ADDENDUM NUMBER: Three (3)

TITLE: IFB FY26 Light Duty Vehicles, Medium Duty Vehicles, and Vans – 1412056646

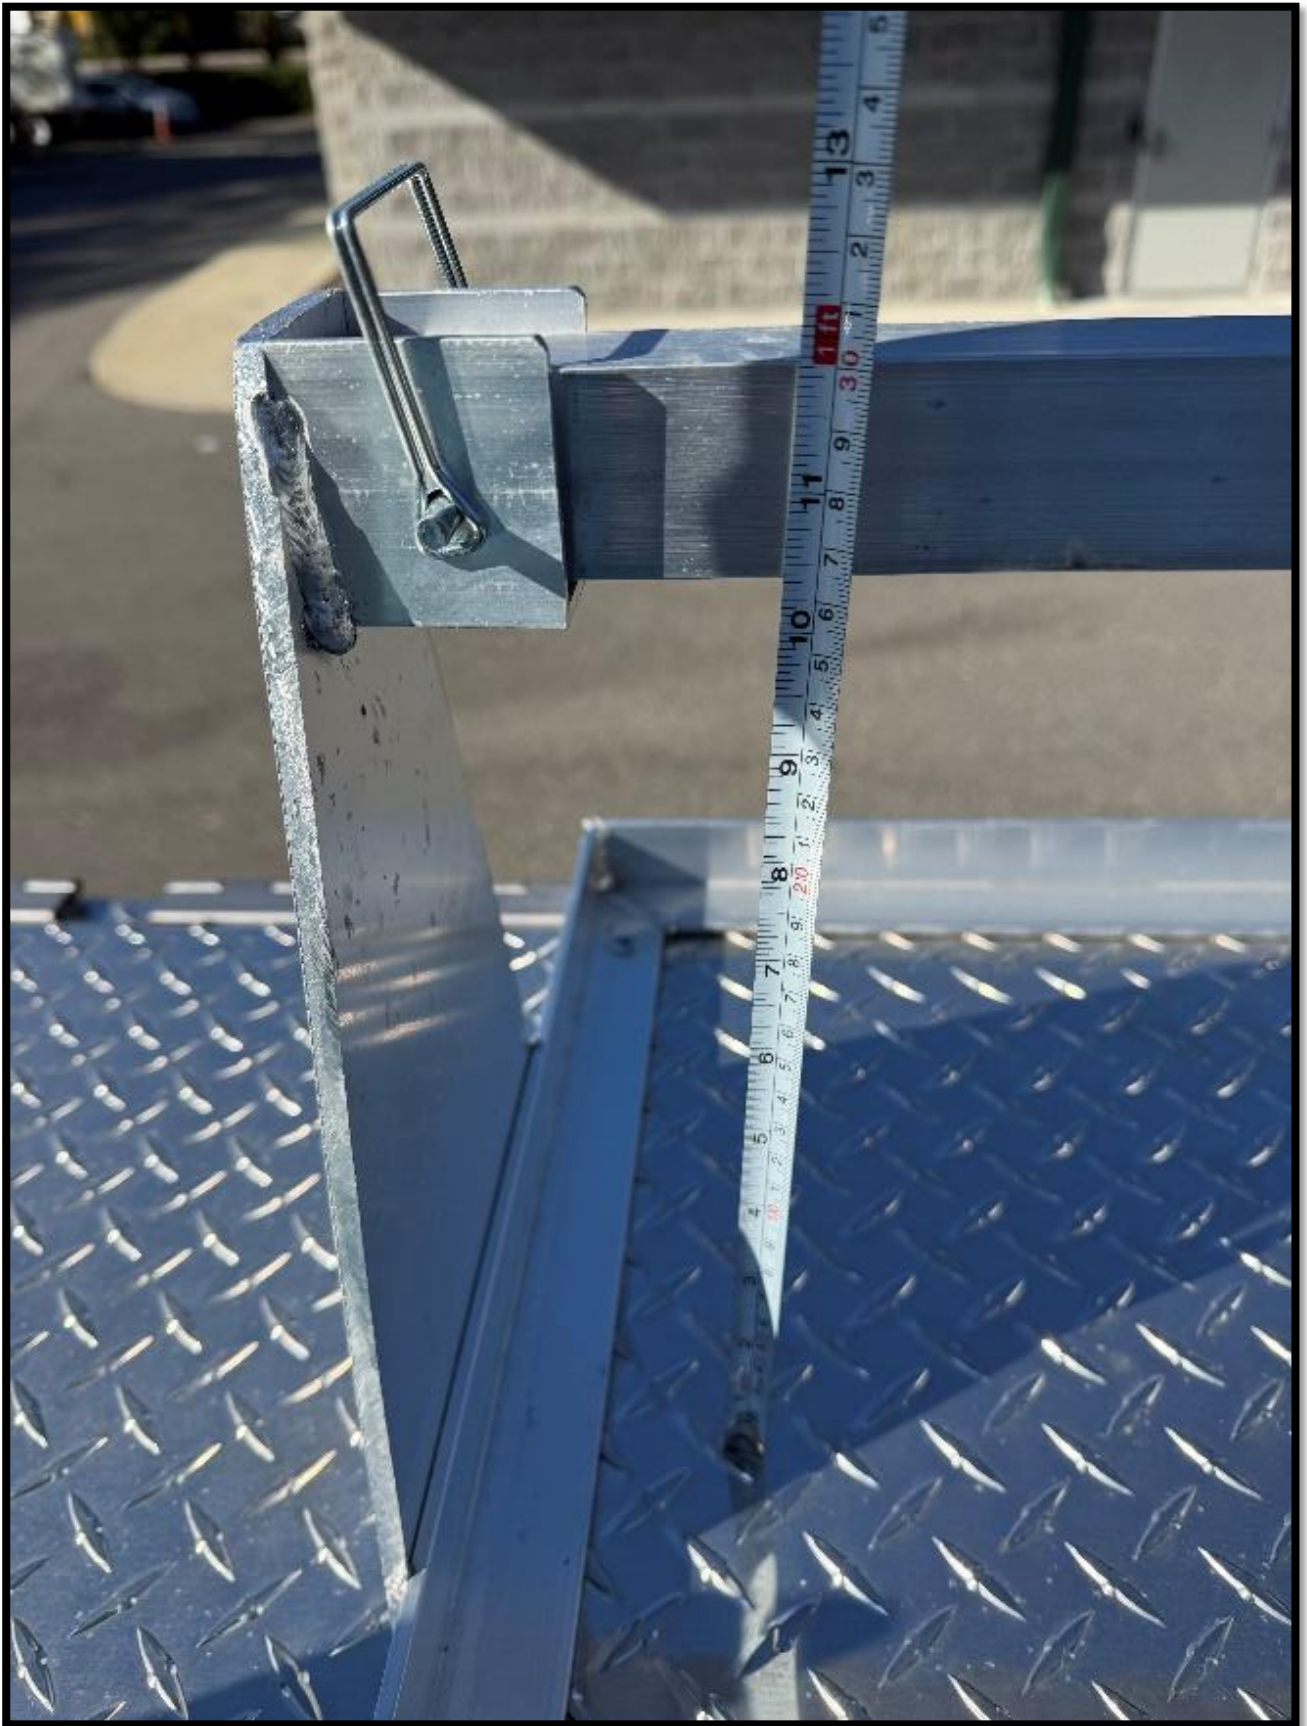
15. Question: Reference - 123 EXT CAB 4WD (Option N): Please provide photos & additional specifications for: "Aluminum 65" Meter Rack."

Answer: Revise and Replace 1412056646 Appendix A - Technical Specs - CLASS 123 4X4 1T STD CAB_EXT CAB DRW D UTIL BODY with Addendum 3 - 1412056646 App A - Tech Specs - CLASS 123 4X4 1T STD CAB_EXT DRW D UTIL BODY. Revised Options F, N, and O to update from 65" Meter Rack to #65 Meter Rack. Revised Option F to update from 37" Meter Rack to #37 Meter Rack. The dimensions for the #65 Meter Rack are approximately 30" Long, 19 3/4" wide and 1' 1/8" tall (10 3/8" to the bottom of the bar that holds down the meters. Please see photos pasted below.

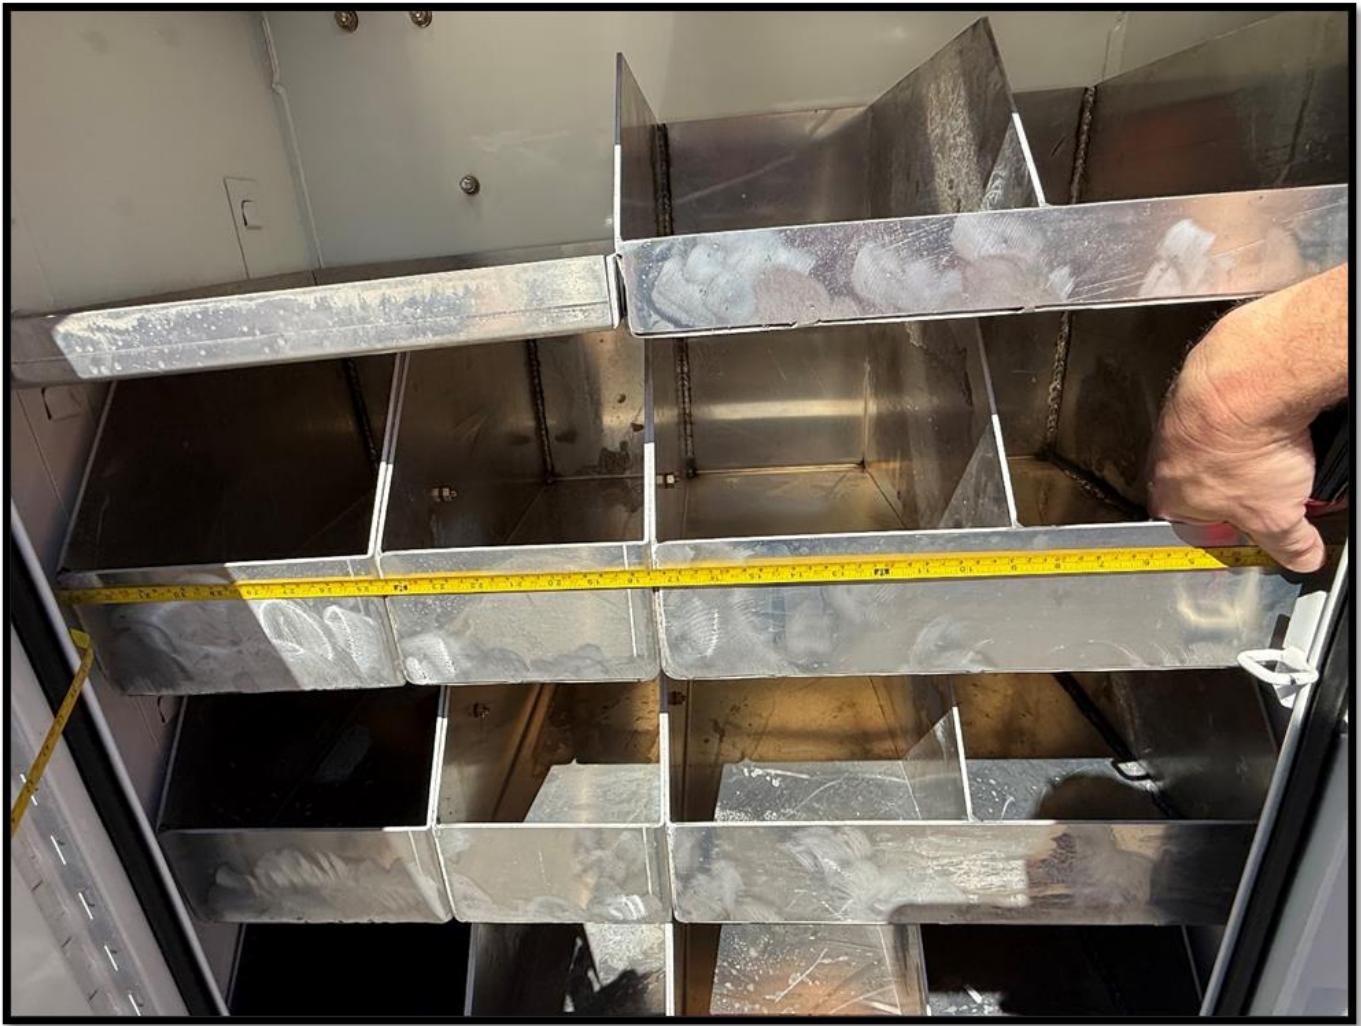
16. Question: Reference - 123 EXT CAB 4WD (Option N): Please provide photos & additional specifications for: LED Lighting Horizontal Not Vertical Mount – where? Inside or outside?

Answer: Inside the bins and under the body.

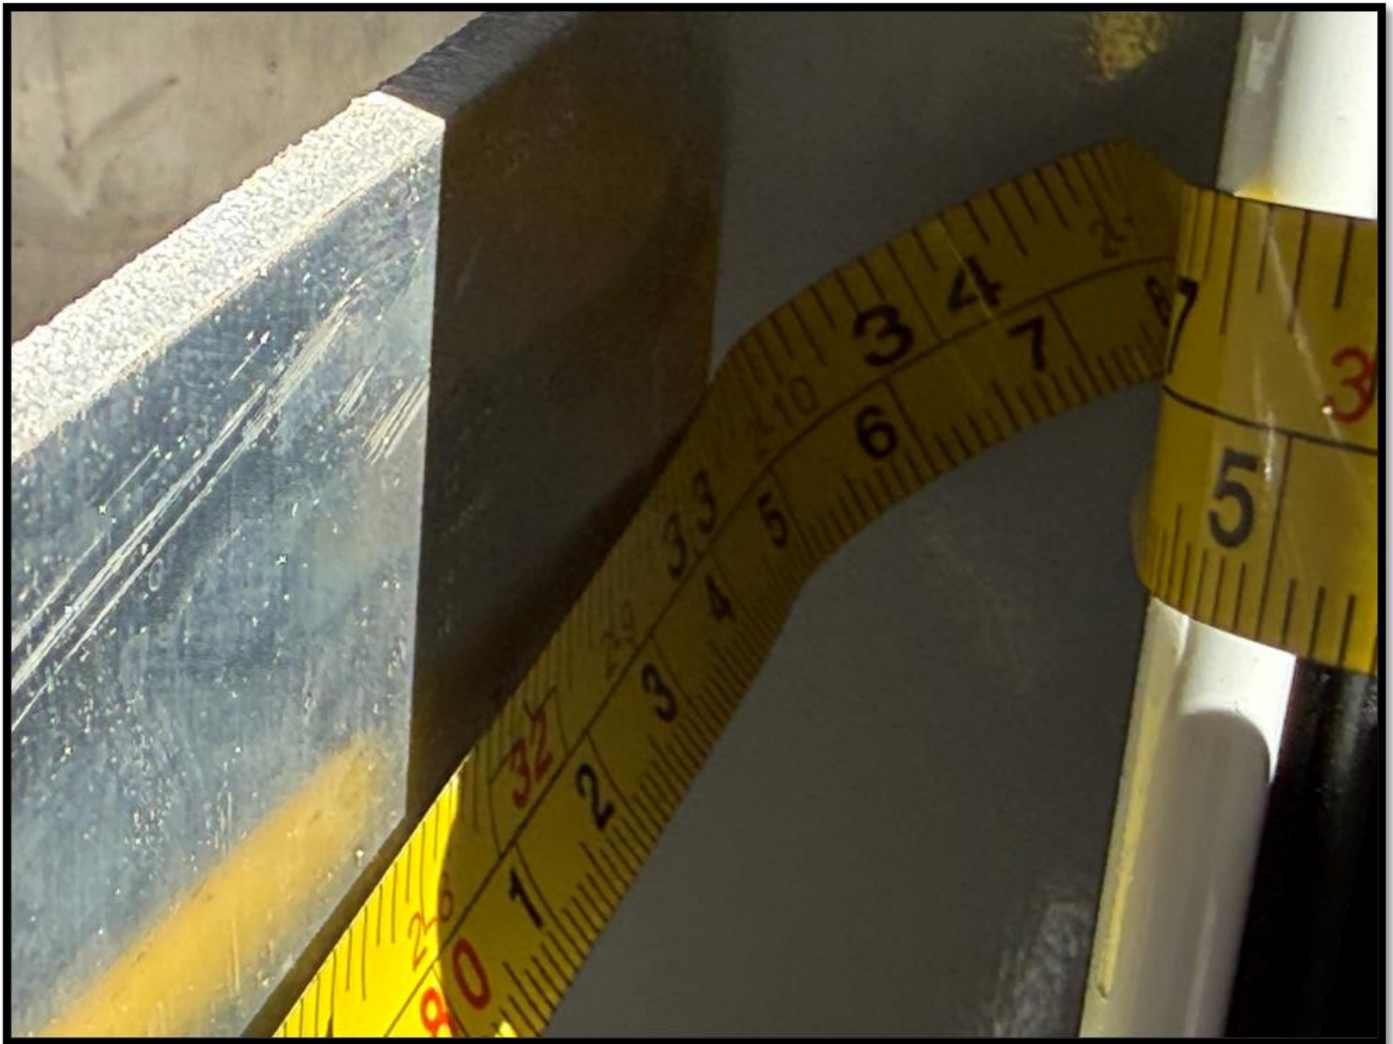
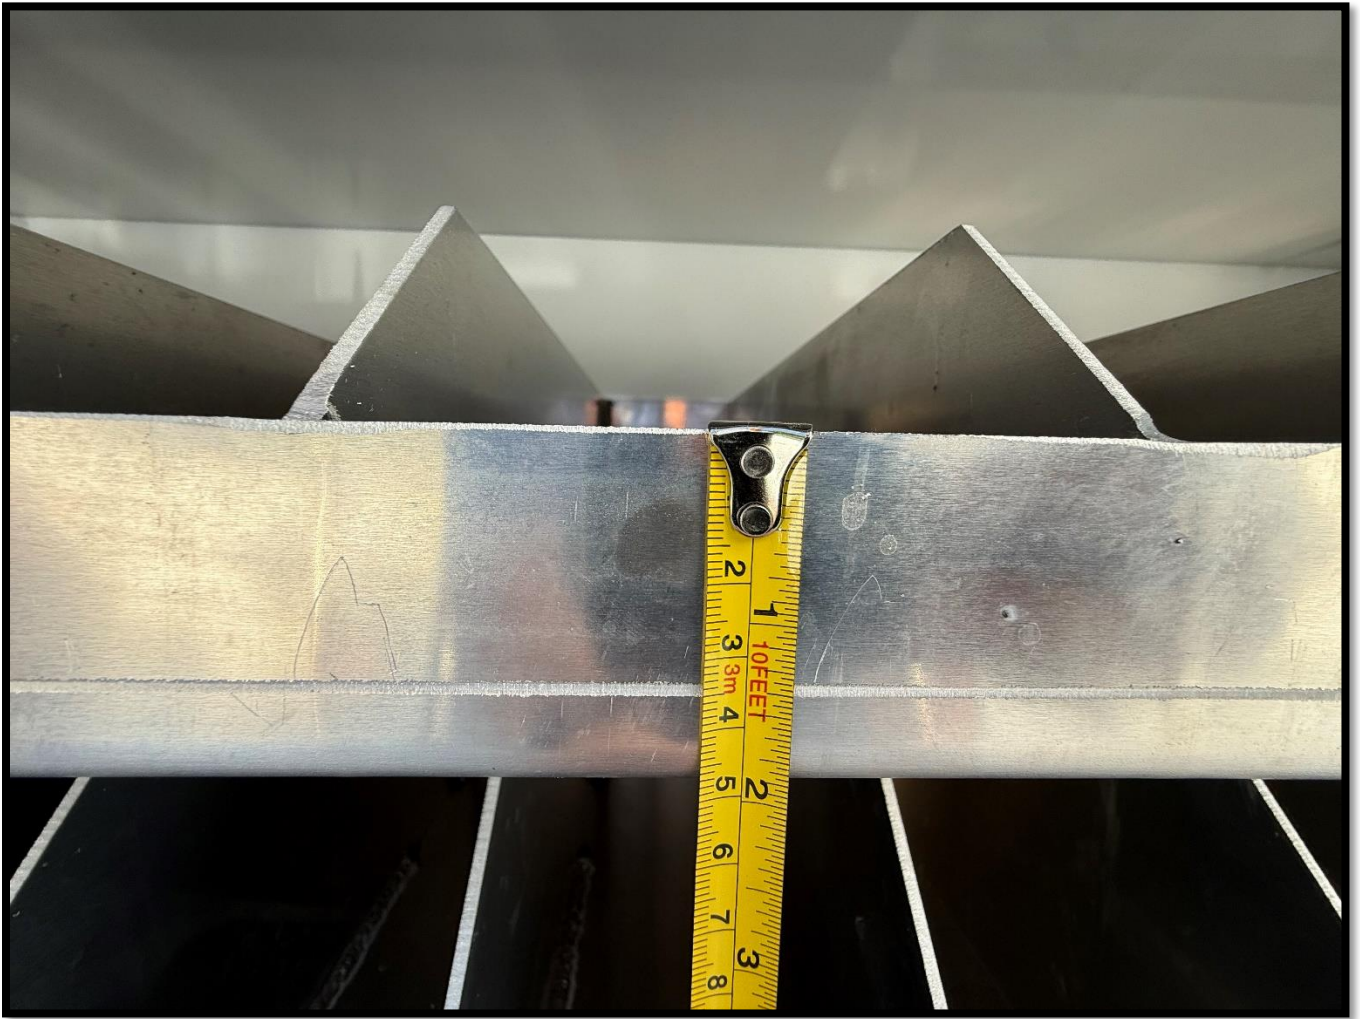
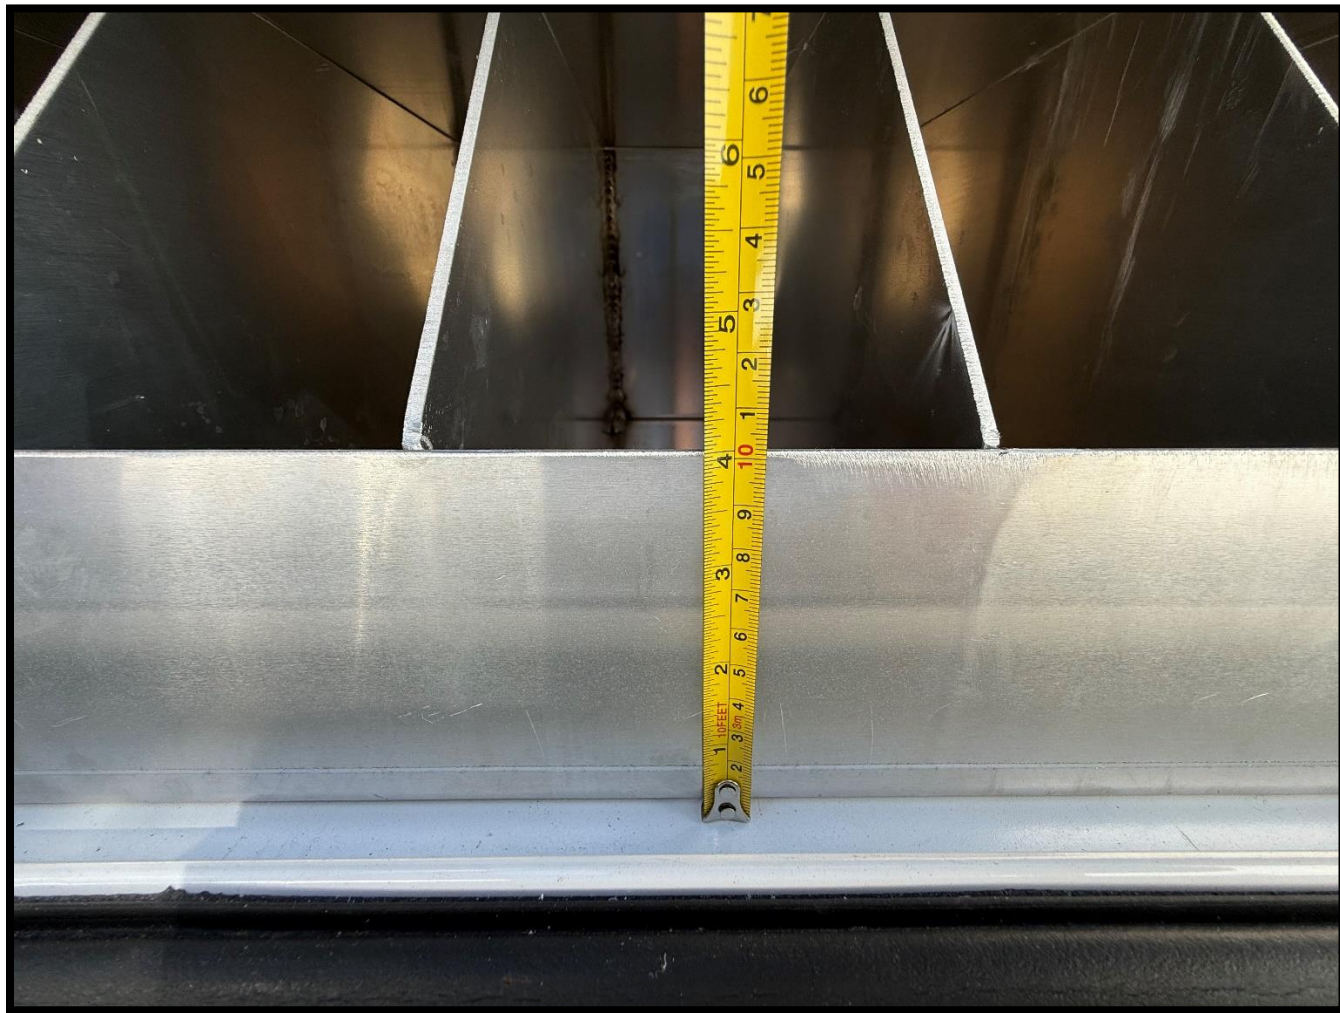
17. Question: Reference - 123 EXT CAB 4WD (Option N): Please provide photos & additional specifications for: Custom Interior Compartment Bins: Aluminum (See referenced vehicle for dimensions/layout). NOTE: Reference JEA COMP Truck # 7154 – Can you please provide photos and further detail of the referenced vehicle?

Answer: Please find photos pasted below.
